Tuesday September 10, 2019
Medway Planning and Economic Development Board
155 Village Street
Medway, MA 02053

MARZILLI SITE PLAN AND GROUNDWATER SPECIAL PERMIT PUBLIC HEARING:

R.P. Marzilli & Company Building Expansion Project Site Plan & Groundwater Special Permit 21 Trotter Drive Tuesday, September 10, 2019

SITE PLAN

WALLACE VILLAGE SITING CONDITIONS PLAN OF LAND IN MEDWAY, MA

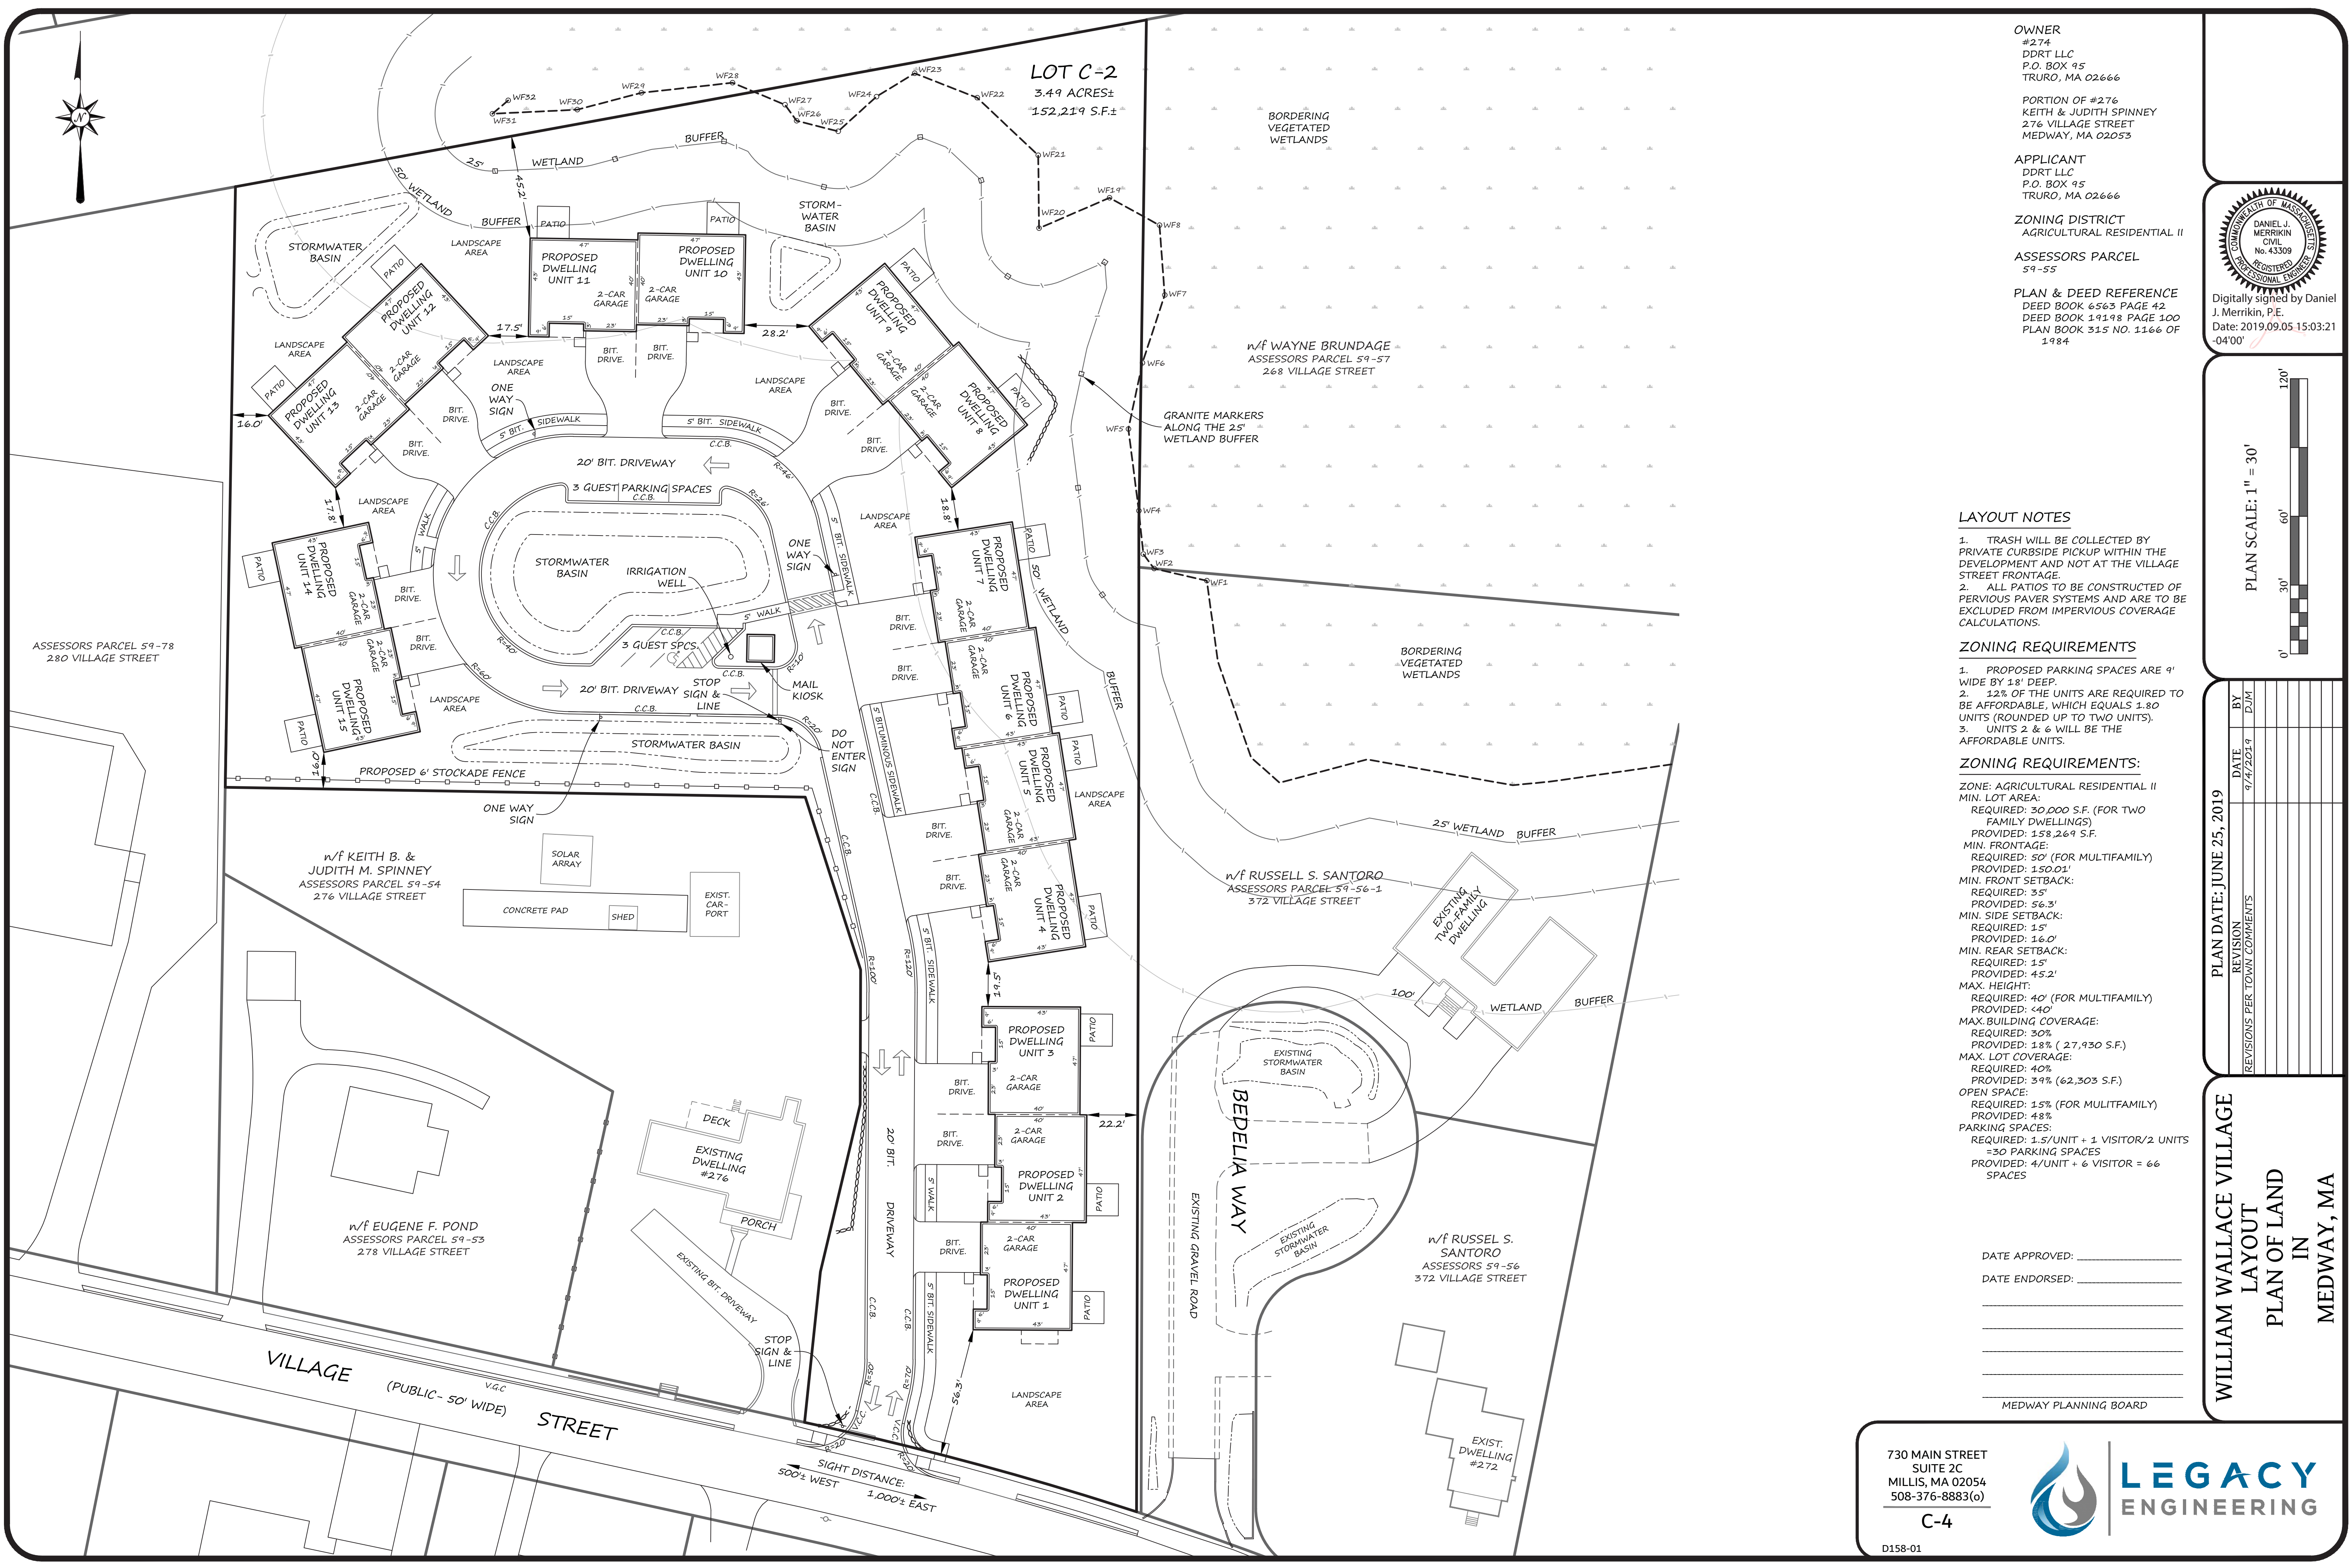
Response: Sight distances have been added to sheet C-4.

WILLIAM WALLACE VILLAGE
UTILITY
PLAN OF LAND
IN
MEDWAY, MA

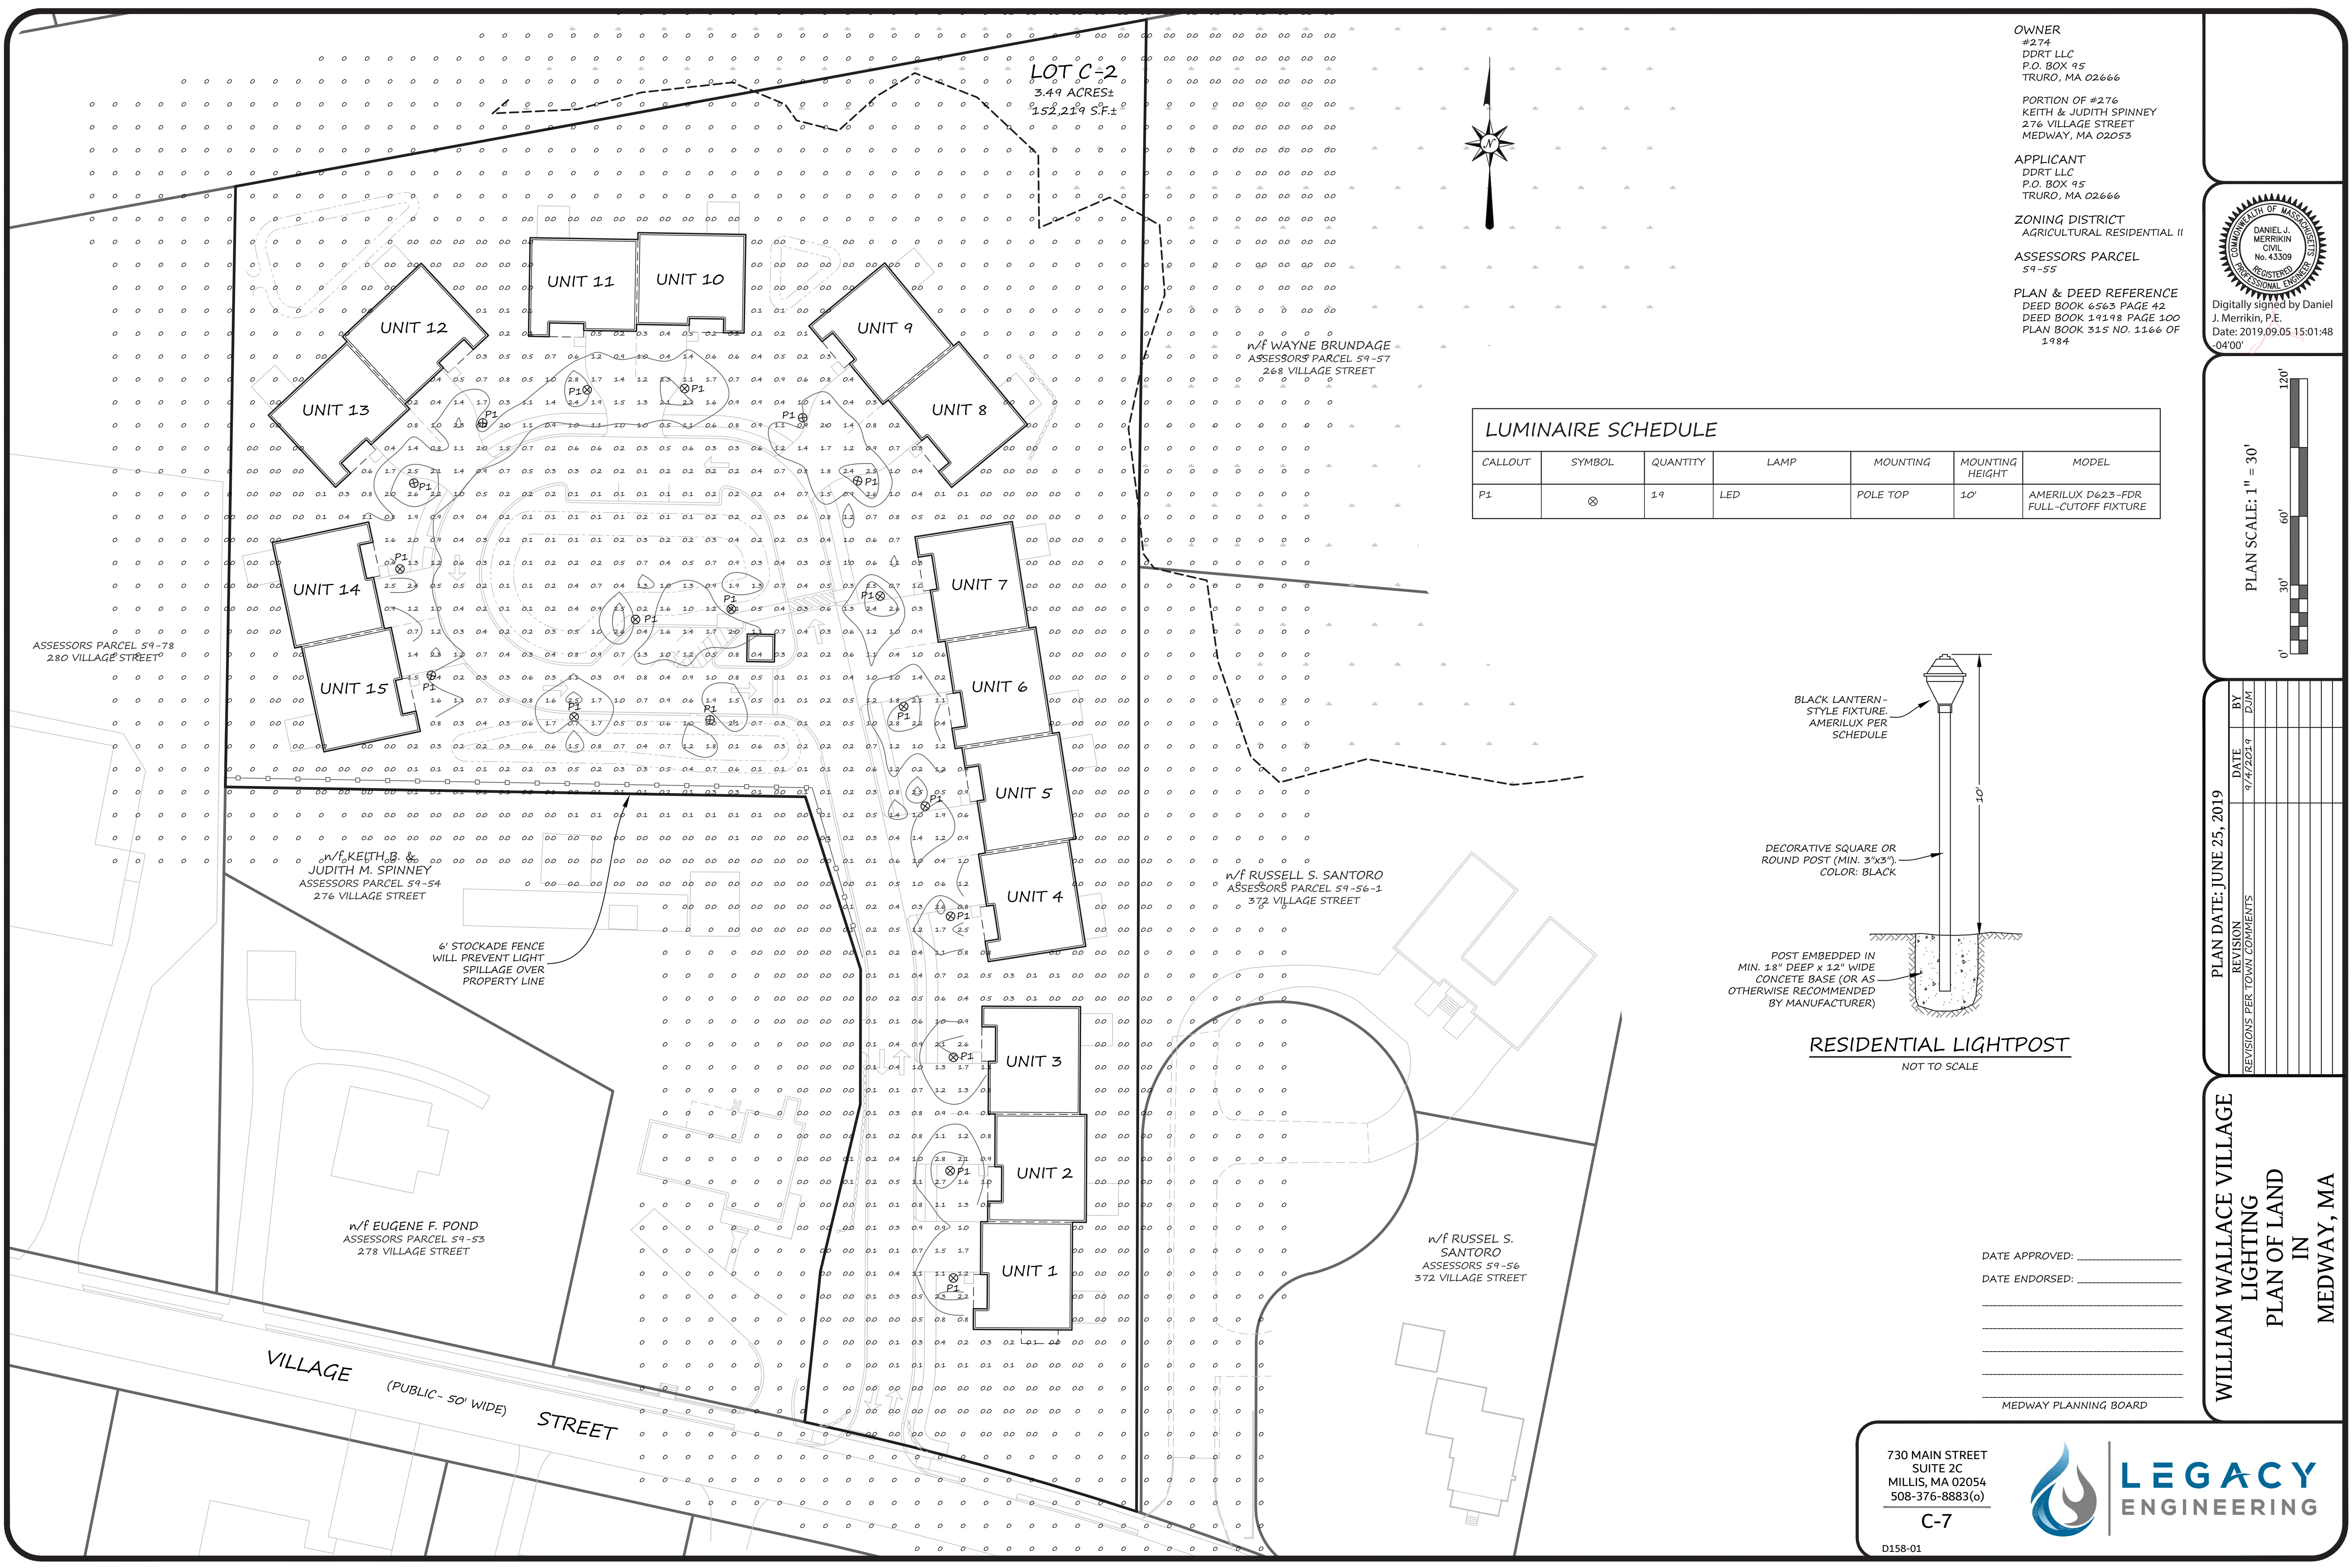
Response: Sheet C-6 has been revised to show a triple gate valve assembly. We do not believe that looping the water main on-site will provide any benefit to the project as water circulation around the circle is unlikely to be significant. The last water service lies at the end of the main and will ensure regular flow through the pipe to avoid stagnant water conditions. Note that the hydrant location has been revised at the request of the Fire Department and that a fire hydrant maintenance plan has been included in the revised O&M Plan.

at 268 Village Street. Sheet C-6 has therefore been revised to propose a direct connection from the new Bedelia Way sewer to the existing street manhole. The Department of Public works has indicated that this approach is acceptable to them.

Response: An irrigation well has been added to sheet C-6 (adjacent to the mail kiosk).
